ADDENDUM NO. 1

DATE: AUGUST 5, 2025

**ALTERNATE C-2
DIAGRAM**
NOT TO SCALE

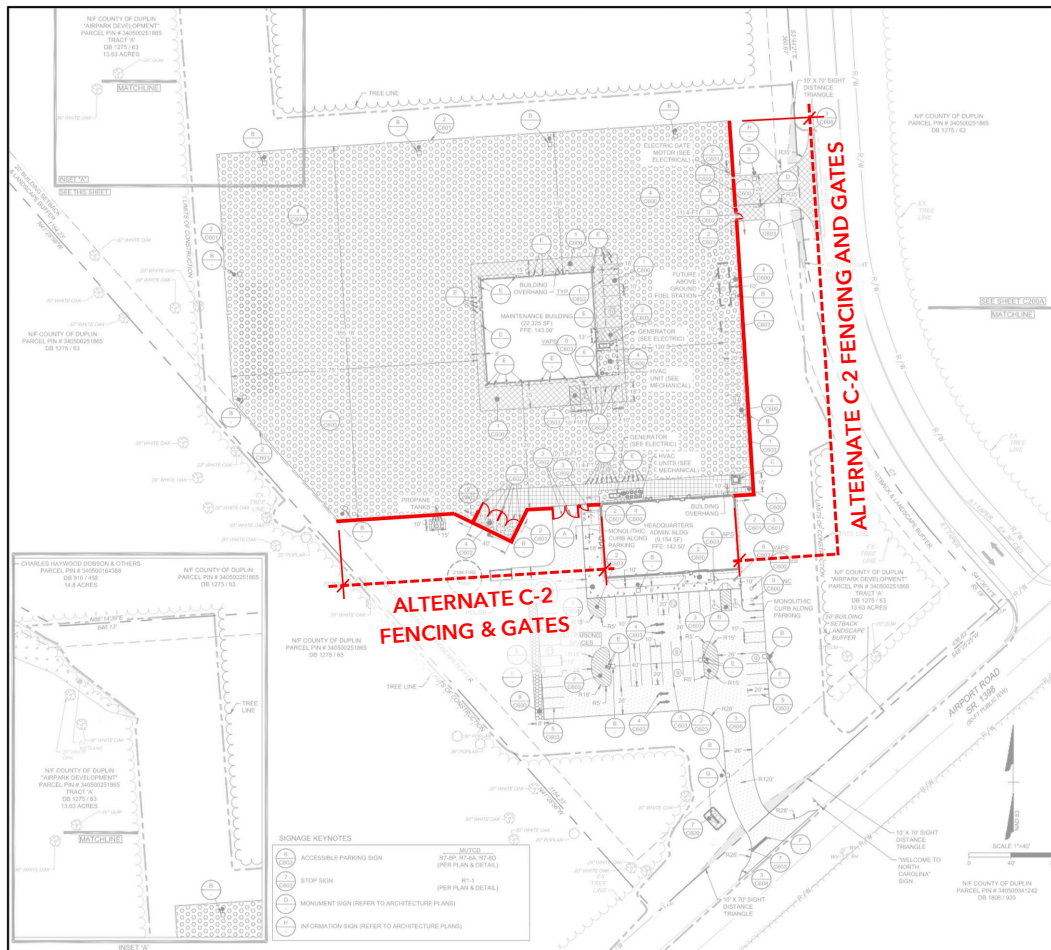
"Alternate No. C-2: Provide ornamental fencing and gates in lieu of black PVC coated chain link fencing and gates for the plan south and plan east portions of the Base Bid operations yard fencing."

Refer to the Alternate C-2 Diagram below that highlights the Alternate C-2 fencing and gates in red.

**ALTERNATE C-3
DIAGRAM**
NOT TO SCALE

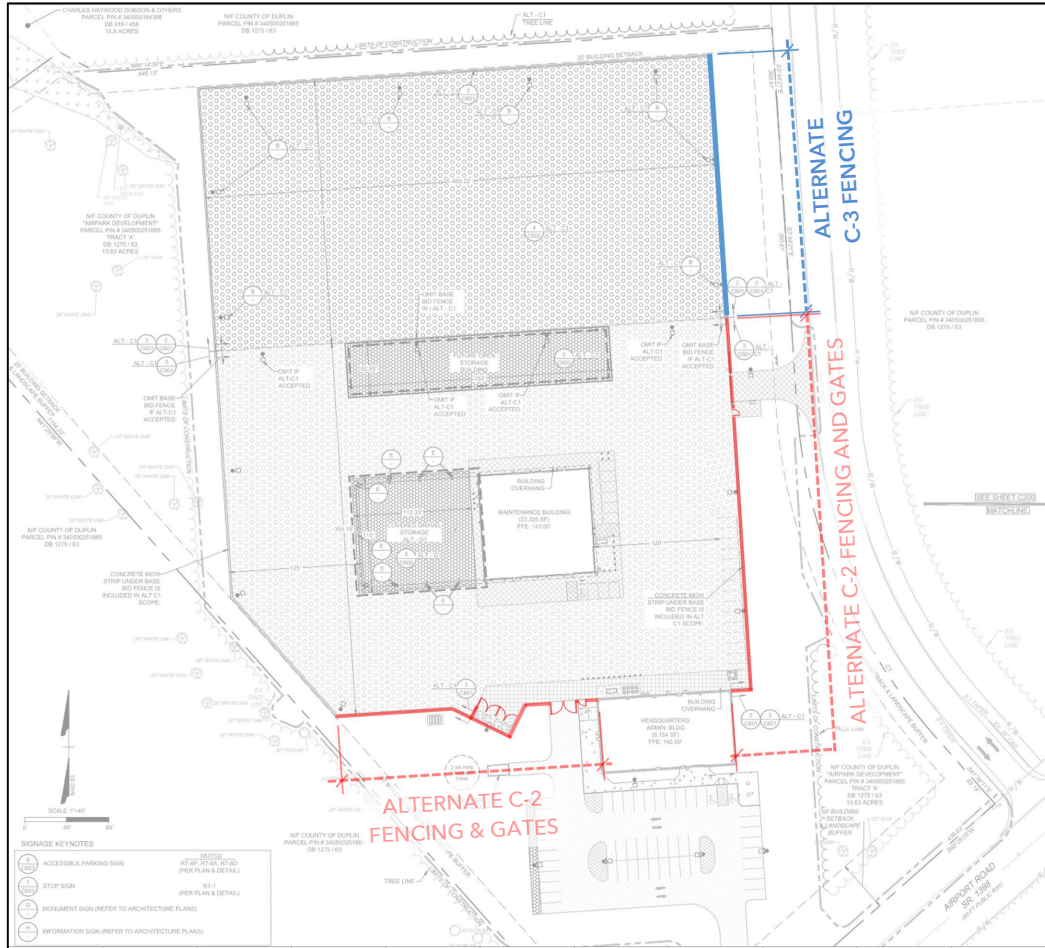
"Alternate No. C-3: Provide ornamental fencing in lieu of black PVC coated chain link fencing for the plan east fencing associated with Alternate C-1."

Refer to the Alternate C-3 Diagram below that highlights the Alternate C-3 fencing and gates in blue.

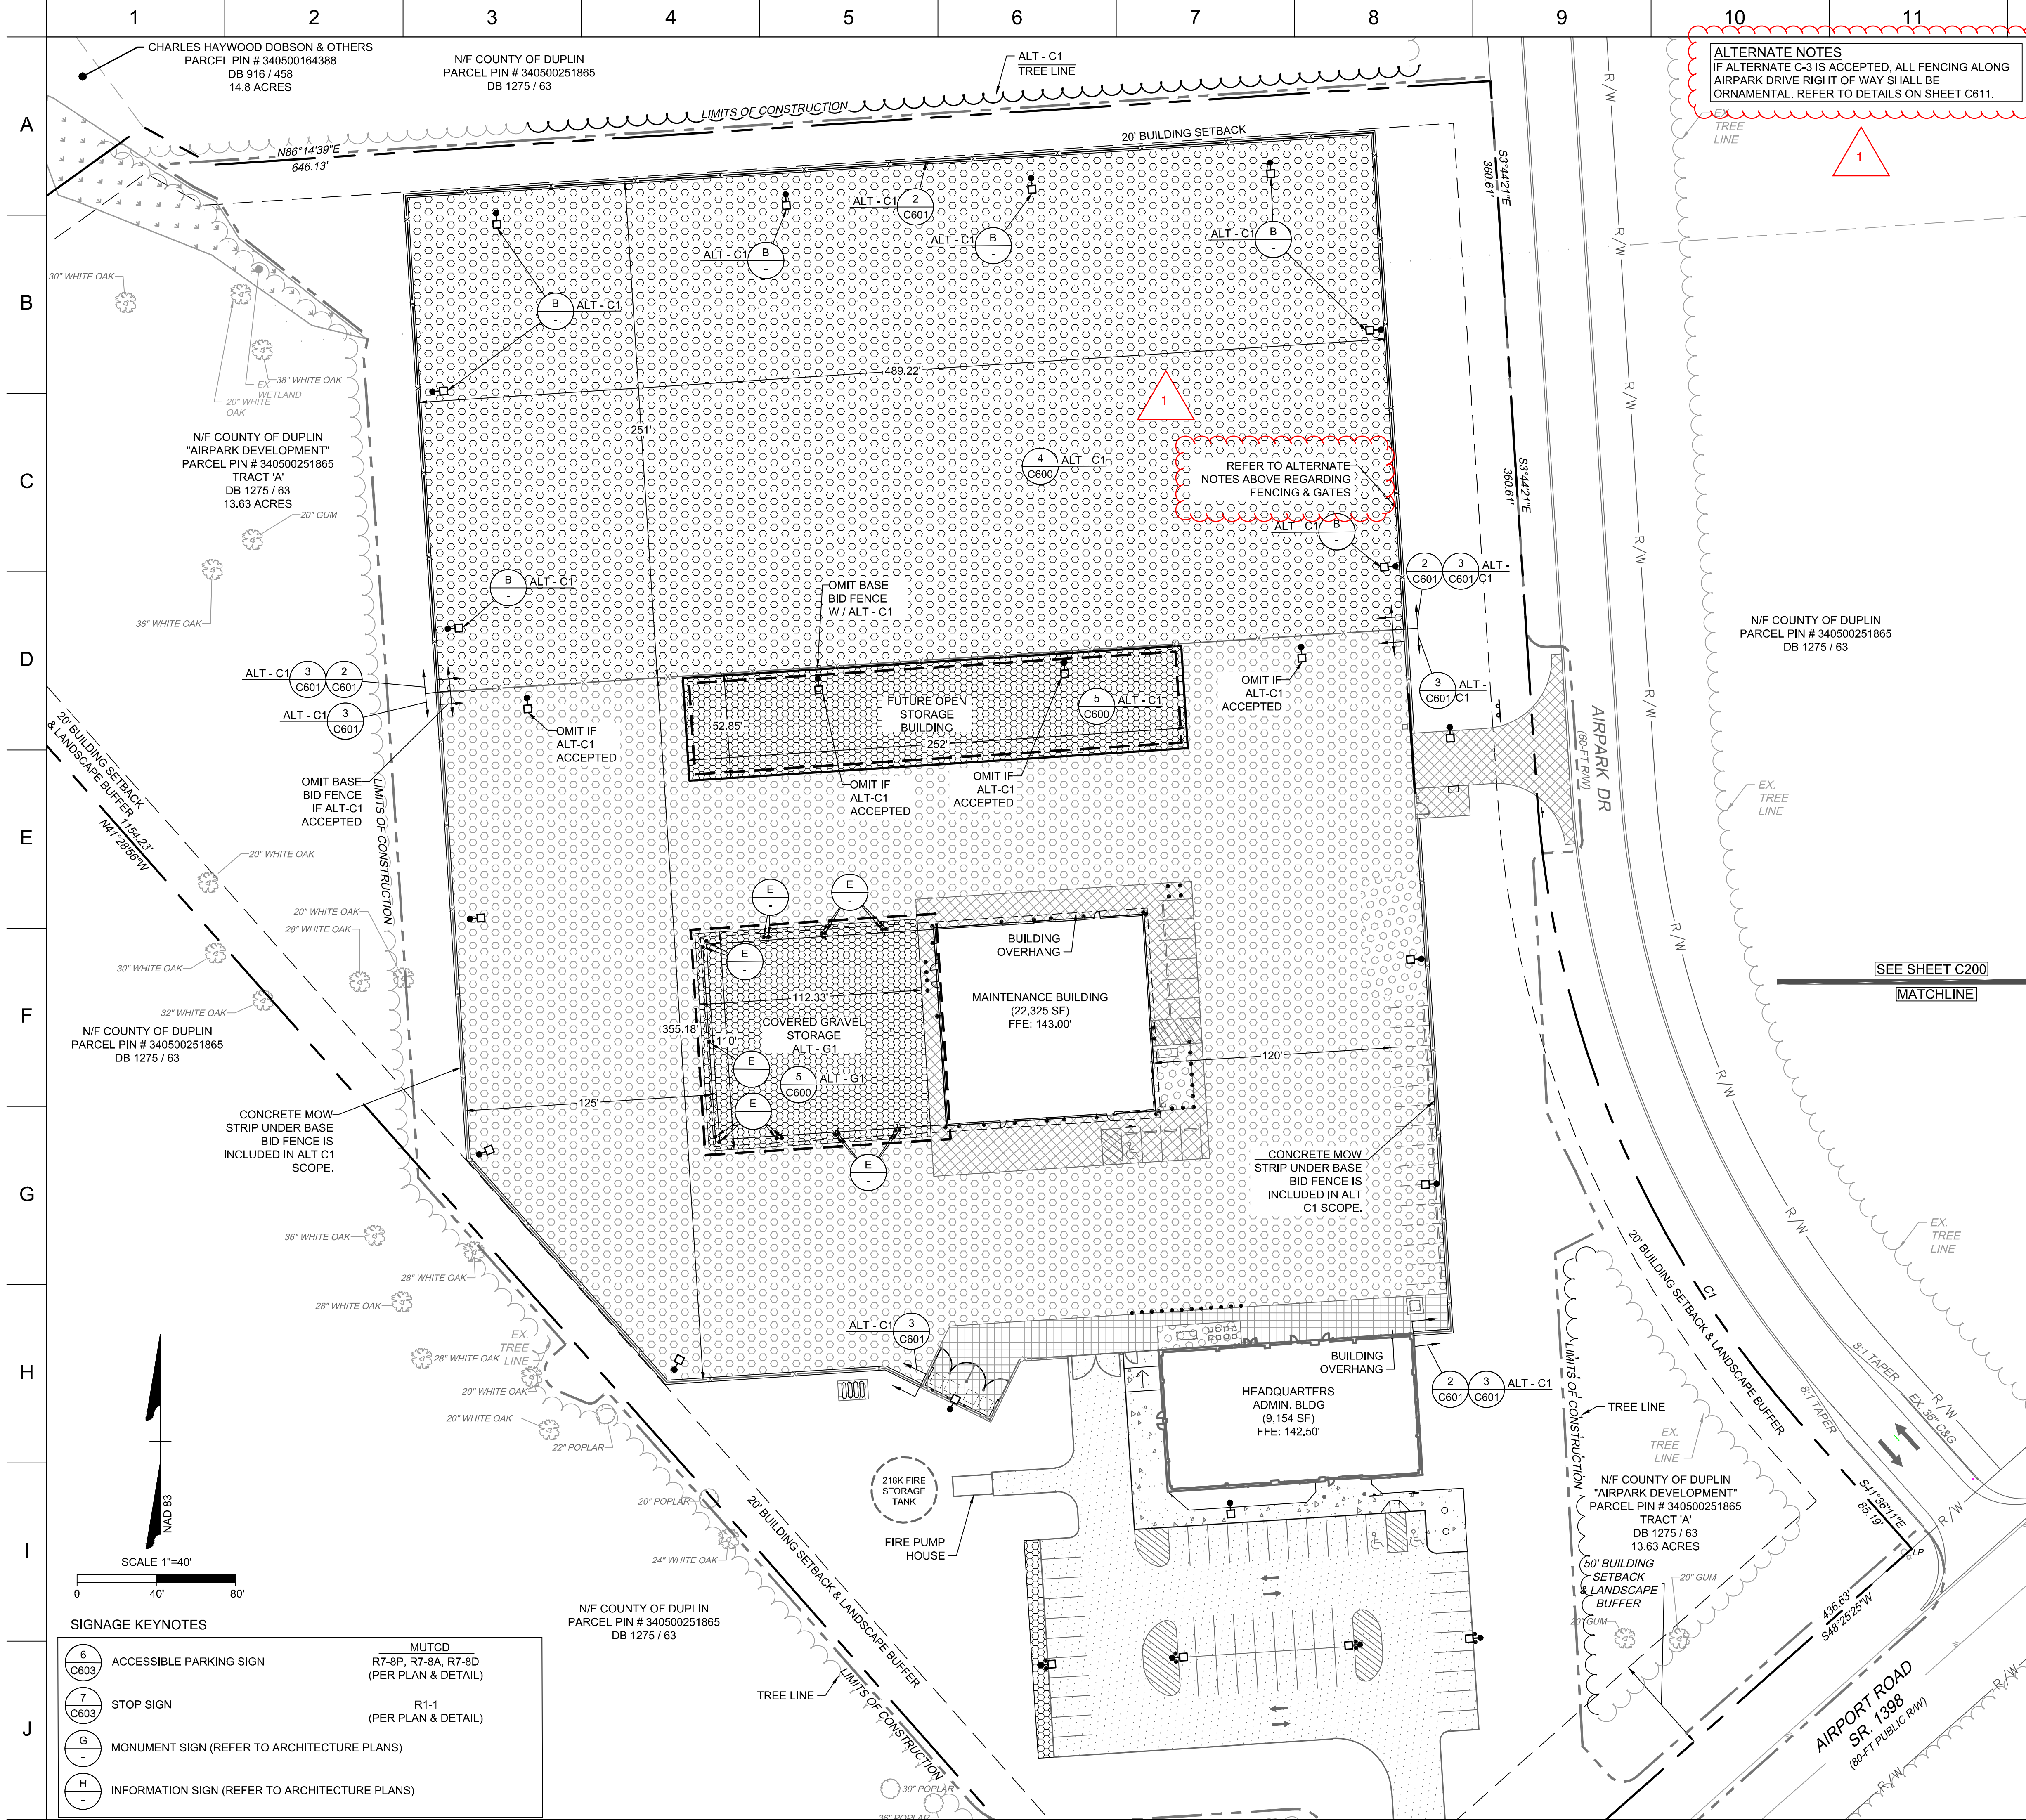
ALTERNATE NOTES
IF ALTERNATE C-2 IS ACCEPTED, ALL FENCING AND GATES ALONG AIRPARK DR AND AIRPORT ROAD SHALL BE ORNAMENTAL. REFER TO DETAILS ON SHEET C611.

CONSTRUCTION DOCUMENTS
DRAWING TITLE:
SITE PLAN - ALTERNATES
SHEET:
C200A

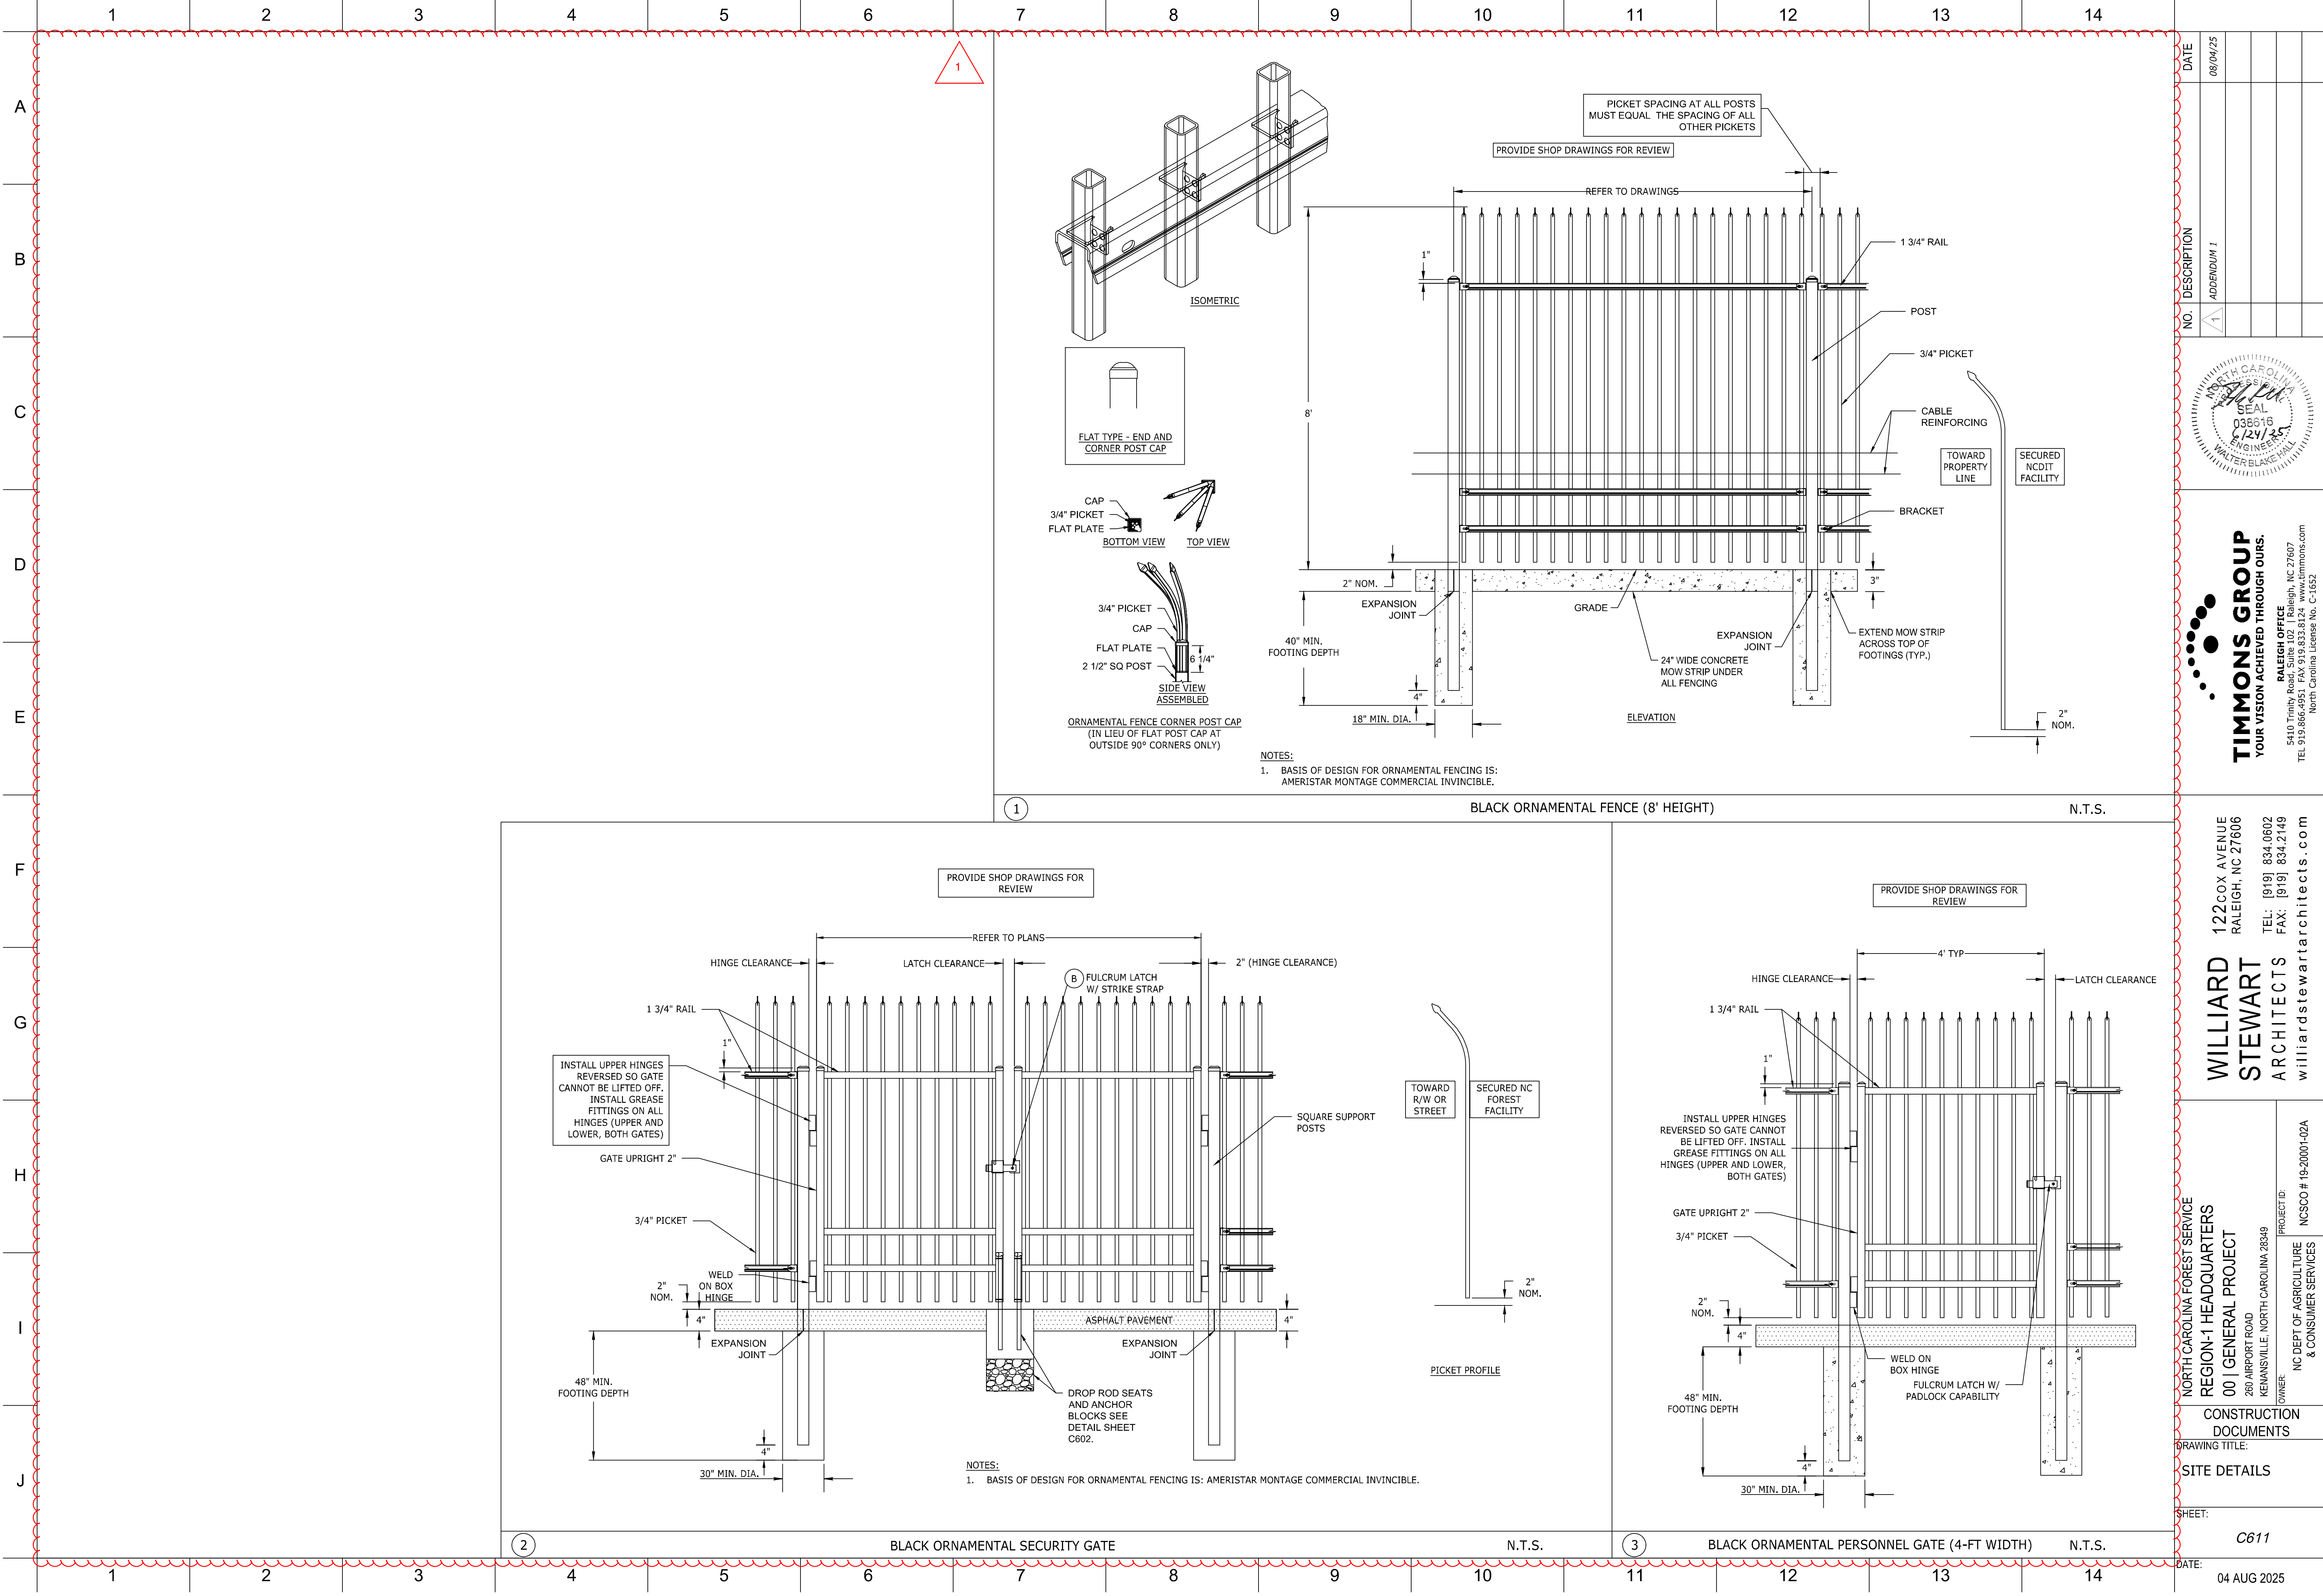
ALTERNATE NOTES
IF ALTERNATE C-3 IS ACCEPTED, ALL FENCING ALONG AIRPARK DRIVE RIGHT OF WAY SHALL BE ORNAMENTAL. REFER TO DETAILS ON SHEET C811.
